Letter Number 2.18.004

Description and Evaluation of the Proposed Changes

**SUBJECT:** Revise the Pilgrim Emergency Plan to Address the Permanently Defueled Condition

Figure B-1h: Emergency Public Information Organization

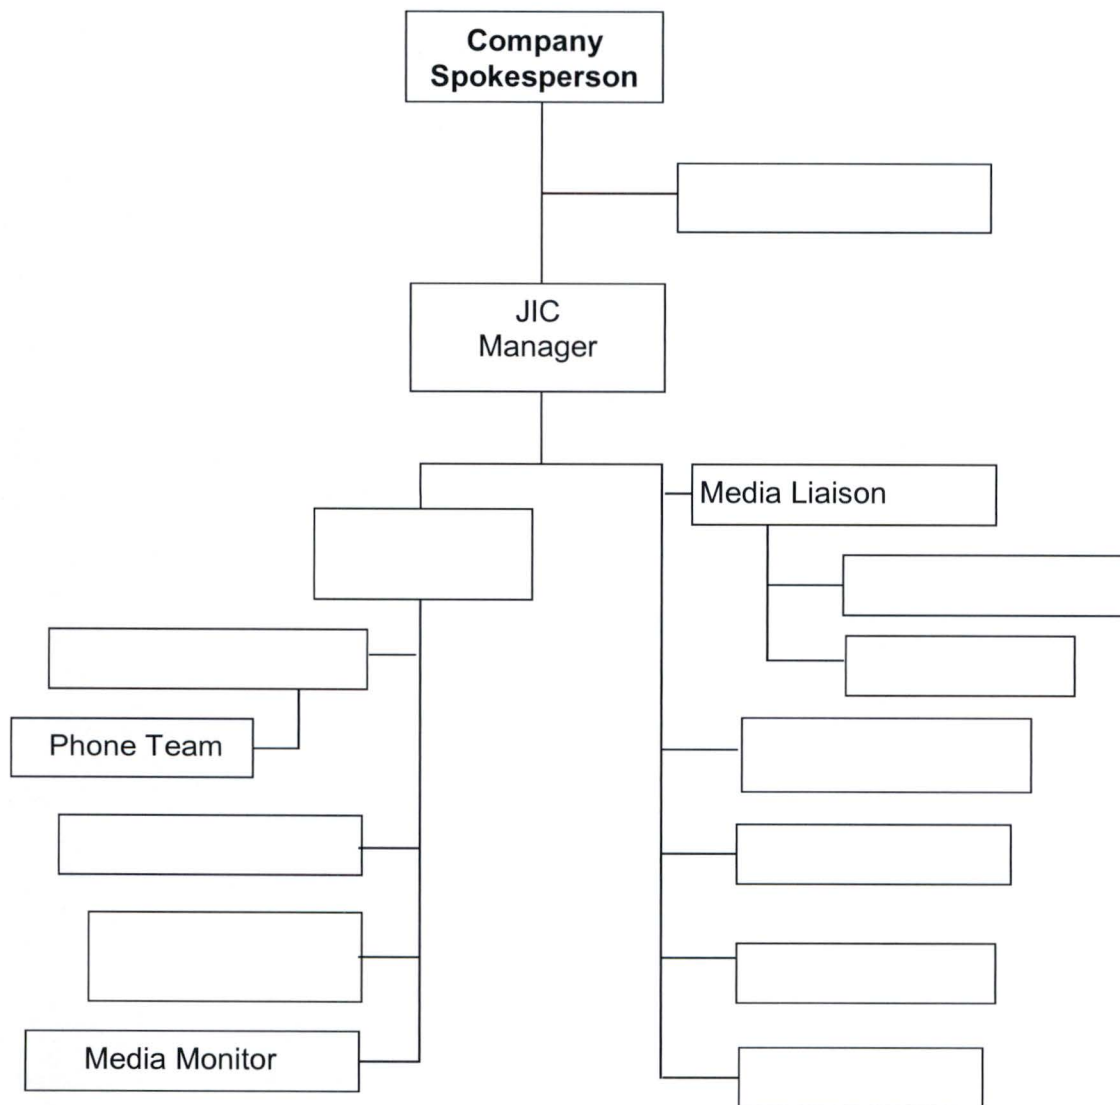
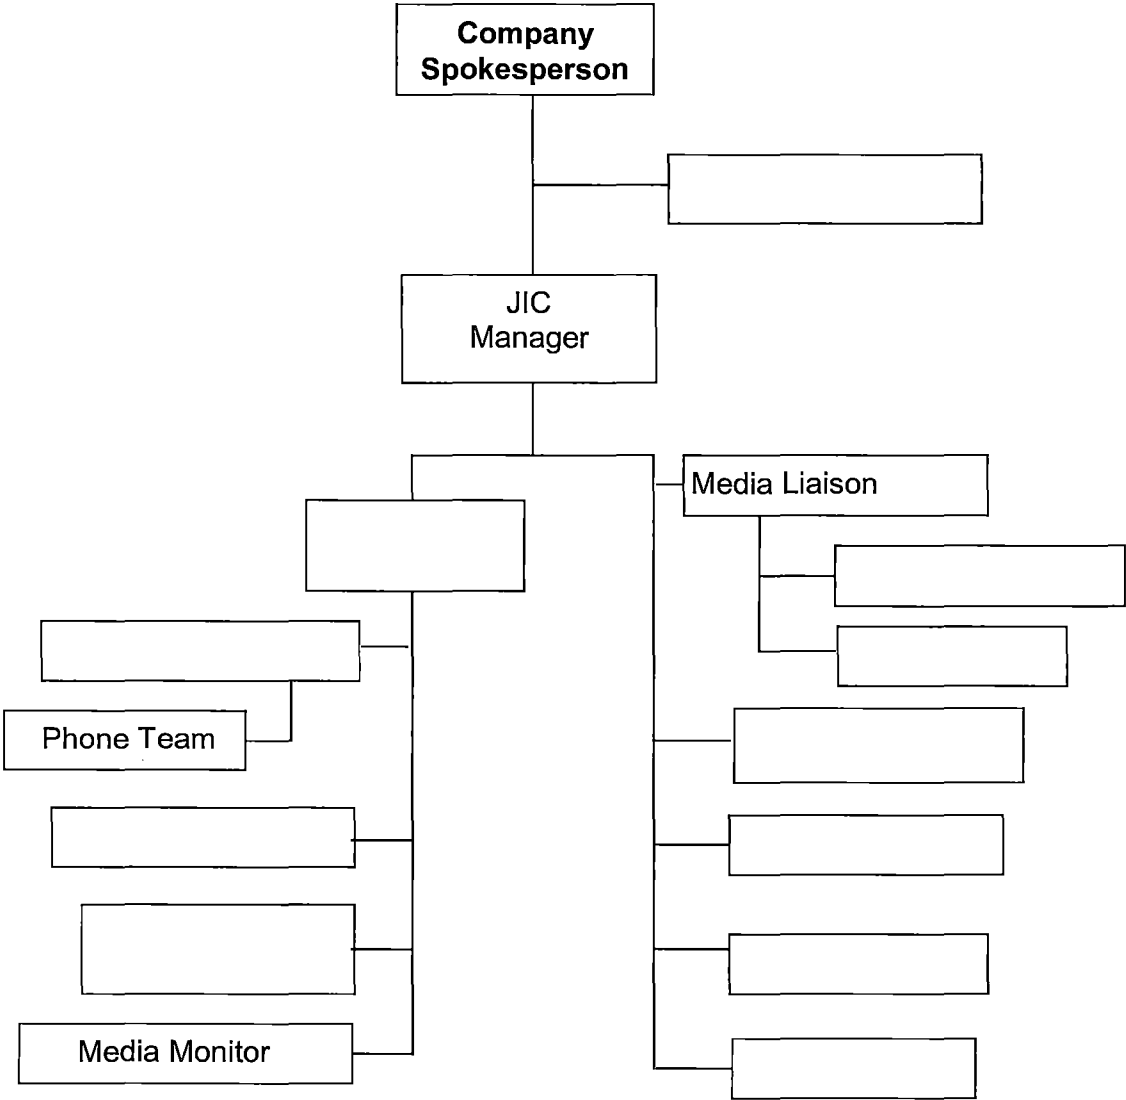
The proposed staffing changes eliminate the following ERO positions in the JIC described in the current PNPS SEP in Part 2, Figure B-1h, "Emergency Public Information Organization."

Part 2, Figure B-1h	Emergency Public Information Organization	Deleted the following positions: JIC Technical Advisor Inquiry Response Coordinator Information Coordinator Technical Assistant Press Release Writer Media Assistant A/V Assistant Logistics Coordinator	These positions will no longer exist in the Permanently Defueled ERO. Duties and responsibilities will be transferred to remaining positions within the JIC.
